Subject: **FCC Class II Permission Change Request for FCC ID: 2ATEV-BL1206-P**

This is to request a Class II Permission Change Request for FCC ID: 2ATEV-BL1206-P, originally granted on 2020/08/11

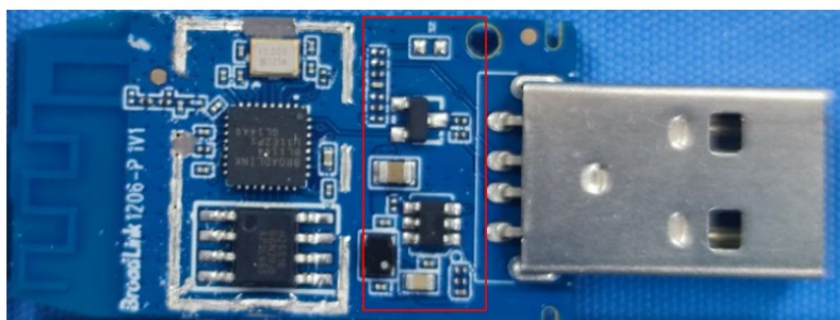
1.The DCDC used on 1V0 is MP2318, and the DCDC use on 1V1 is SGM61410. Because the DCDC has been changed, so the peripheral circuits are changed too.

Before(1V0):

Now(1V1):
